## DESIGN COMMISSION REGULAR MEETING AGENDA

# Design Commission Design Review

<b>Project No:</b>	DSR18-004
<b>Brief Description:</b>	Study Session
<b>Location:</b>	2856 80 <sup>th</sup> Ave SE Mercer Island WA 98040; Identified by King County Tax Parcel #5452300540
<b>Applicant:</b>	Scot Carr, PUBLIC47 Architects
<b>Staff Contact:</b>	Robin Proebsting, Senior Planner

Mercer Island Design Commission Study Session  
November 14, 2018

# Existing Streetscape

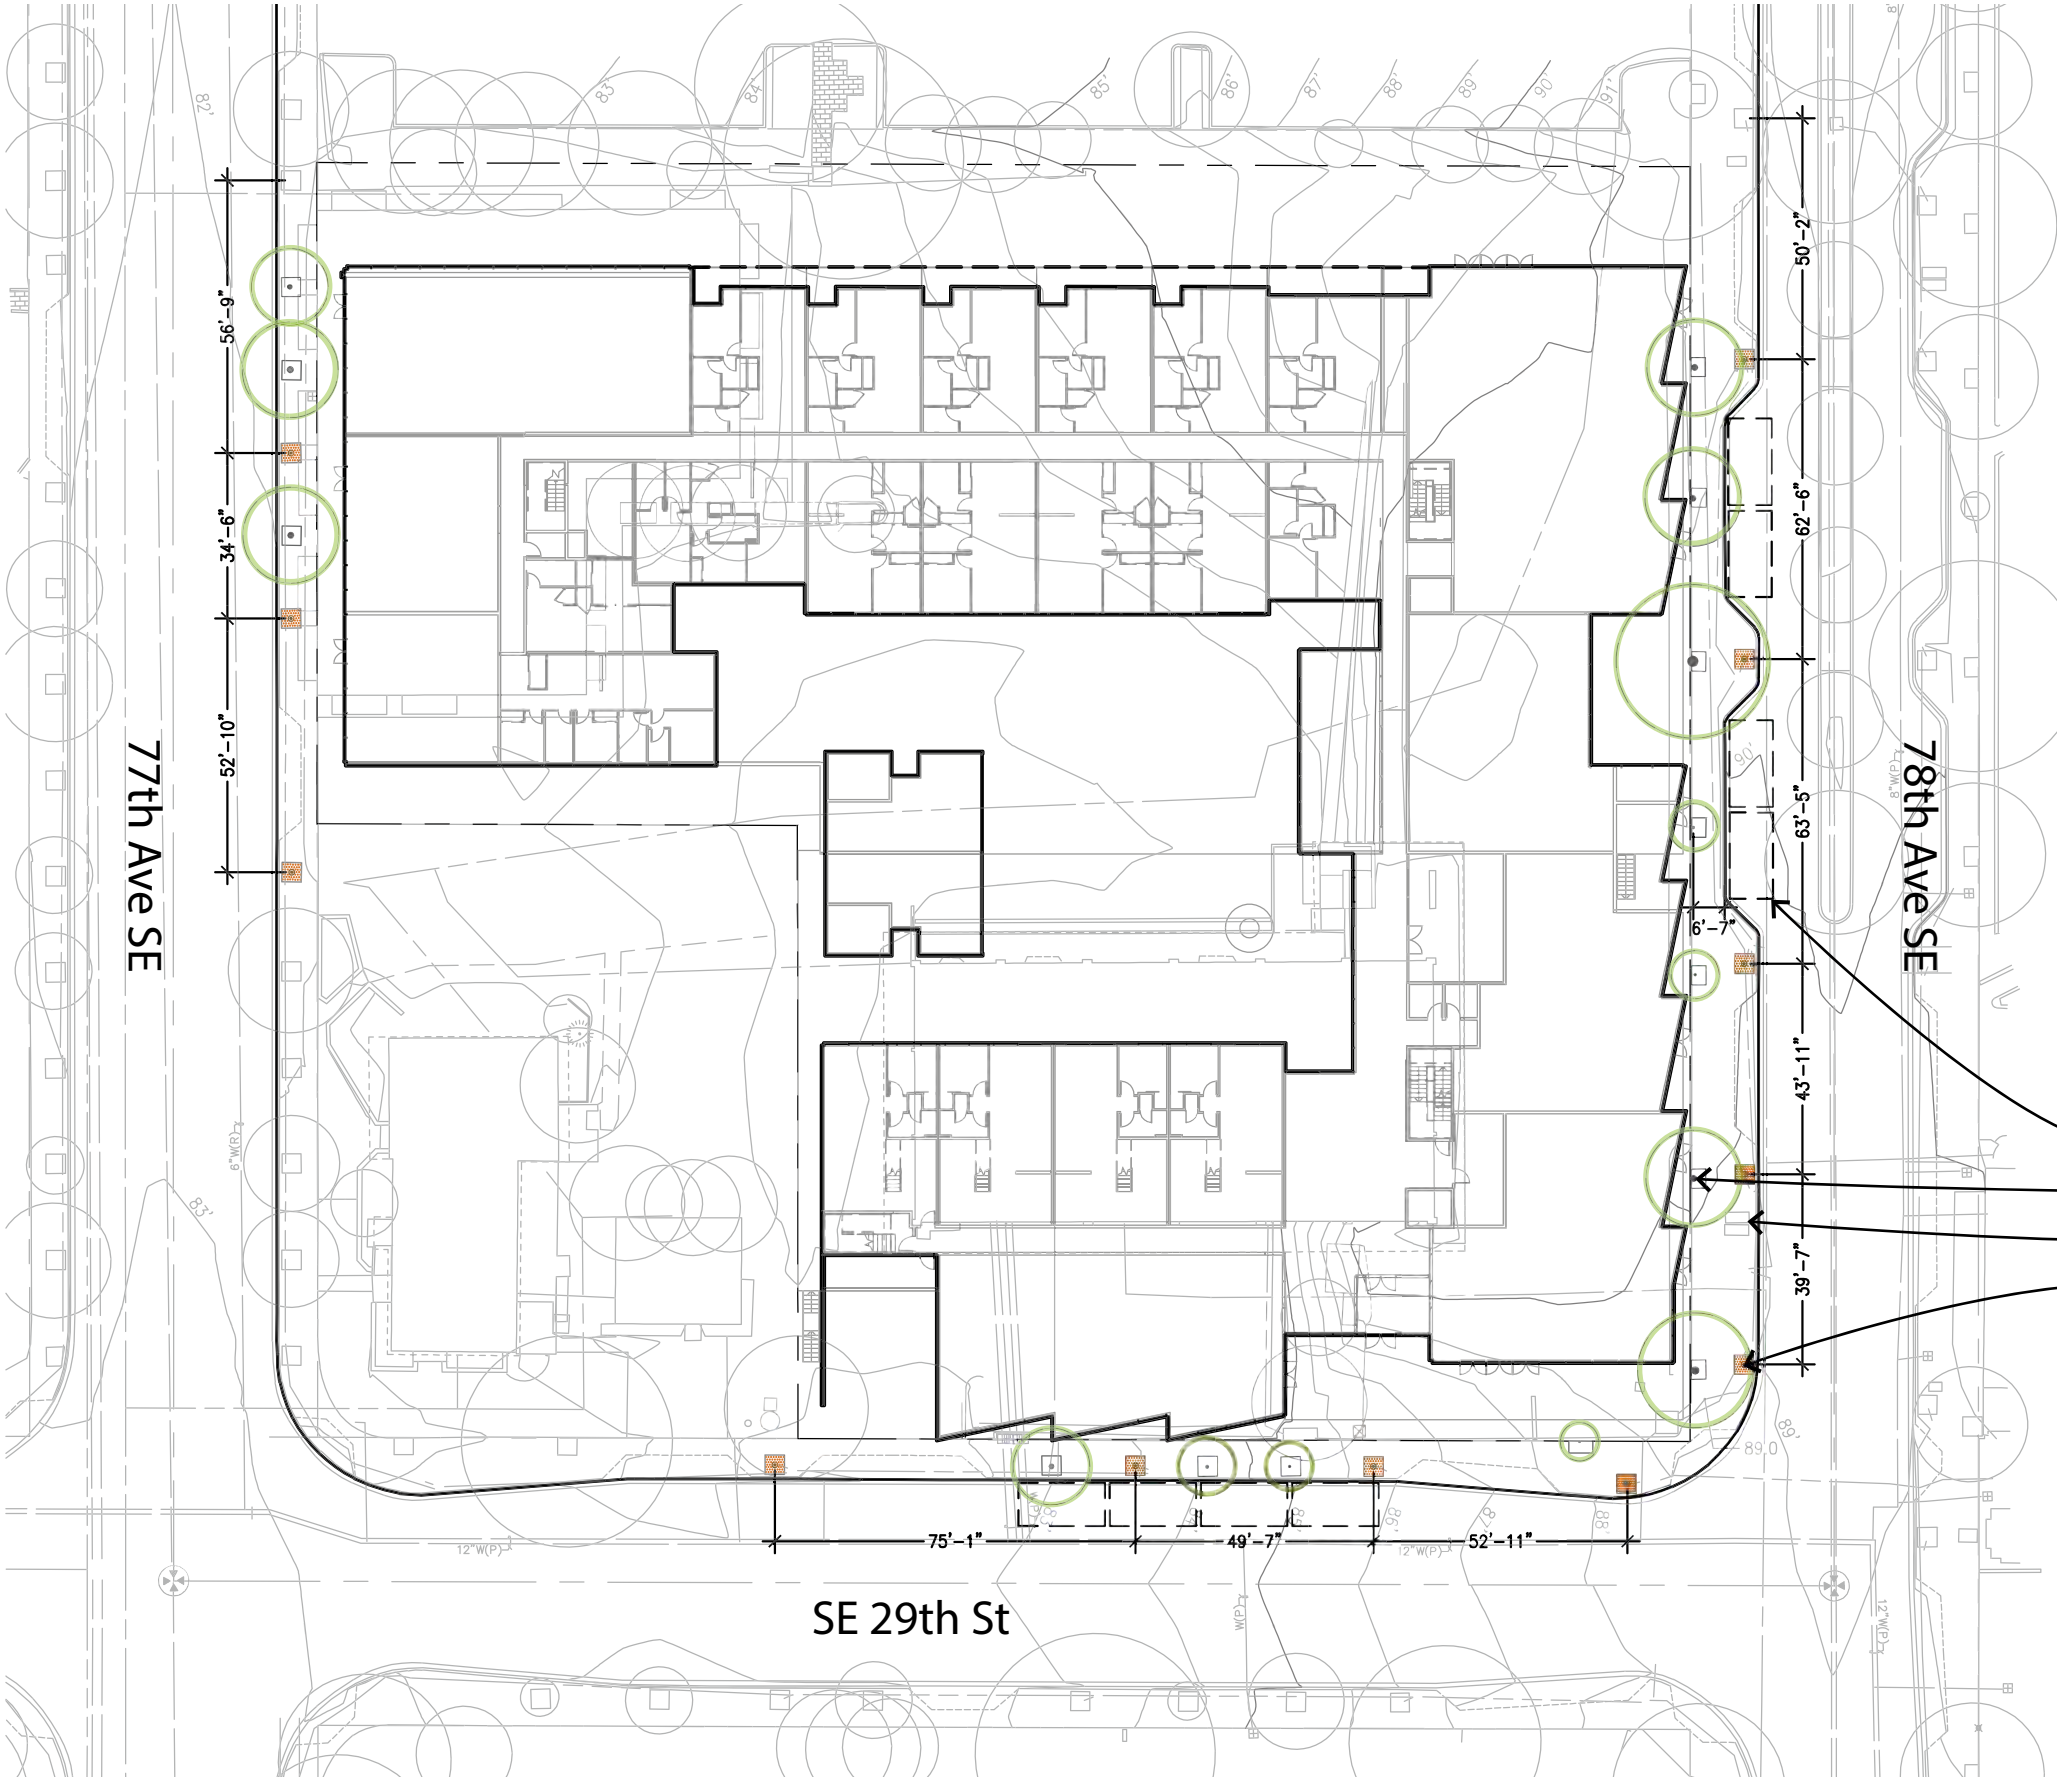
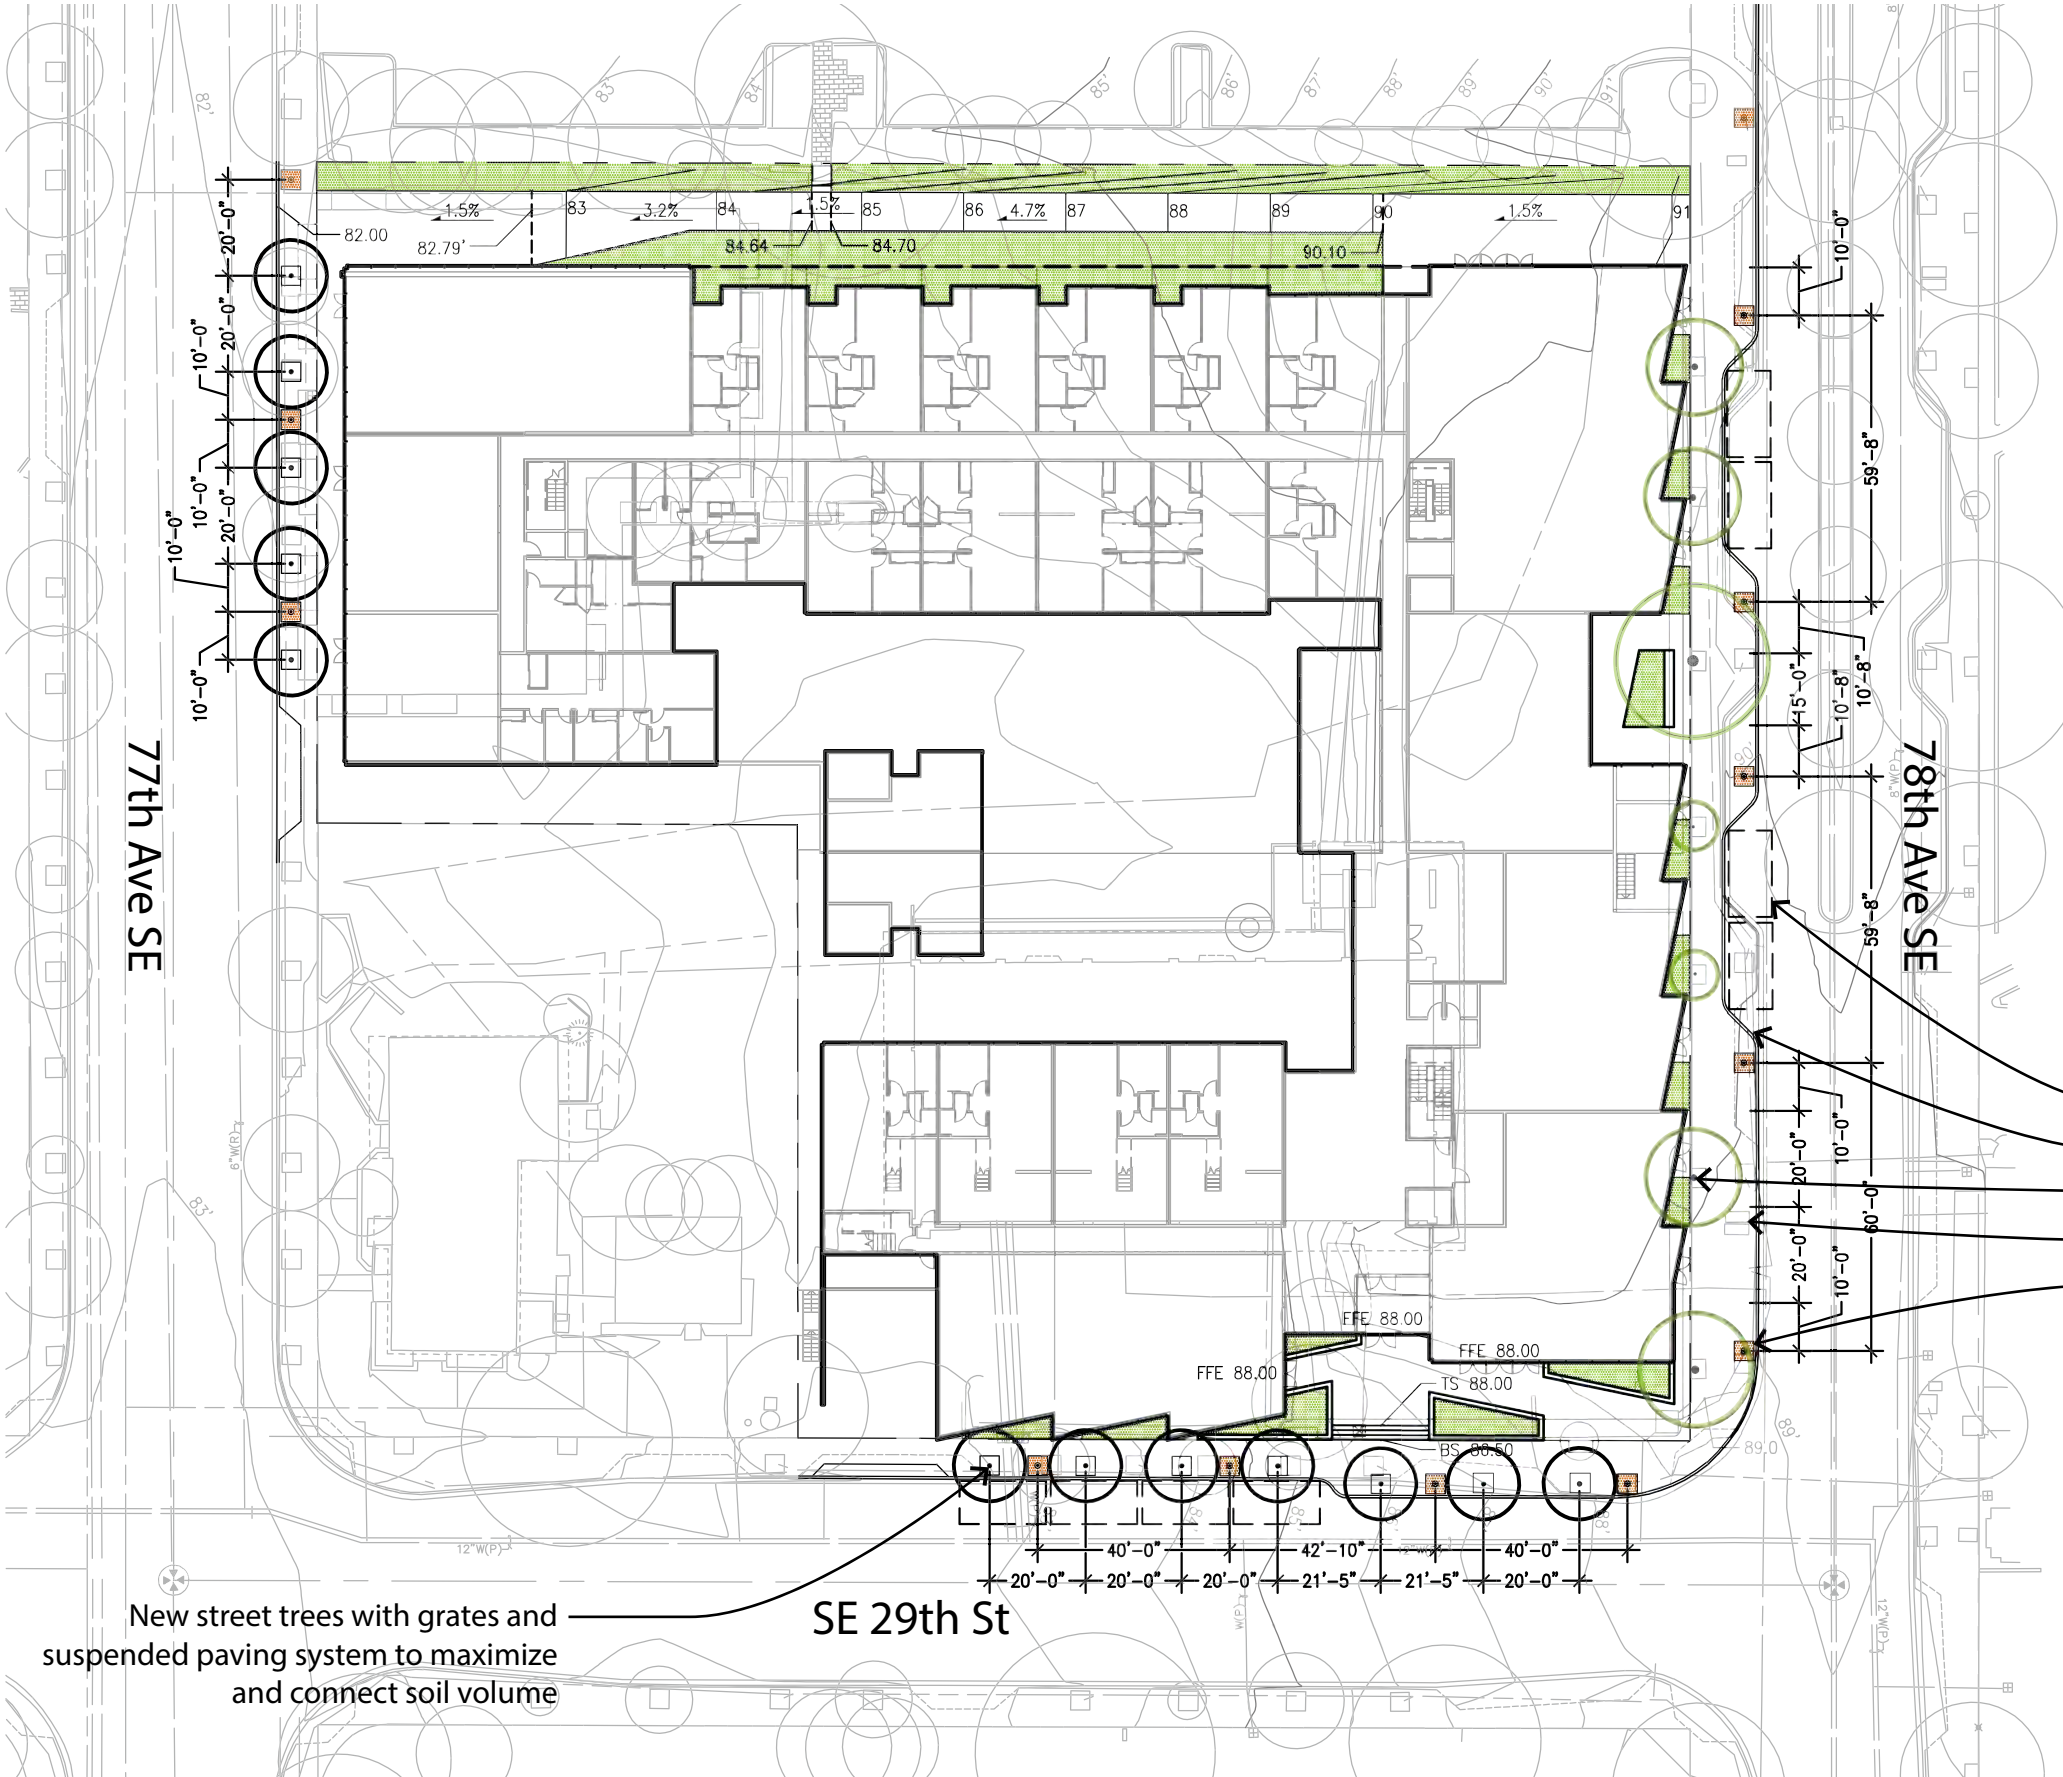
One of the applicant’s specific questions is about removing street trees in the right-of-way along 78th Avenue SE. MICC 19.11.120 requires street frontages along 77<sup>th</sup> Avenue and 78<sup>th</sup> Avenue to be improved as required in Figure 14 of MICC 19.11. MICC 19.11.120 allows the design commission to grant a modification to the nature or extent of any required street

improvements for 4 reasons. One of the reasons that could apply at this site would be reason(D) which states “If other unusual circumstances preclude the construction of the improvements as required.” Staff does not know of any unusual circumstances at the applicant’s site. To reconfigure the street frontage along 78th Avenue, the applicant is proposing to remove the street trees, and replant trees in a suitable number and type per the city arborists requirements. The trees are located at the back of the sidewalk which is not in conformance with Figure 14 because the trees separate pedestrians from the buildings, rather than separating traffic from pedestrians. The trees are outgrowing their tree grates and are becoming girdled by the grates. The city arborist has stated that the maples along 78th are not the best suited species to the site. The city arborist has stated that he will probably recommend removal. MICC 19.11.070(B)(2)(b)(i) states” “Prominent trees should be preserved to the fullest extent”. This is the only code section to the Town Center standards that addresses tree retention.

***If the arborist recommends removal of the trees, and the trees are replanted according to the city’s Streetscape Manual using city approved tree species, would the commission be ok with removal of the existing street trees?***
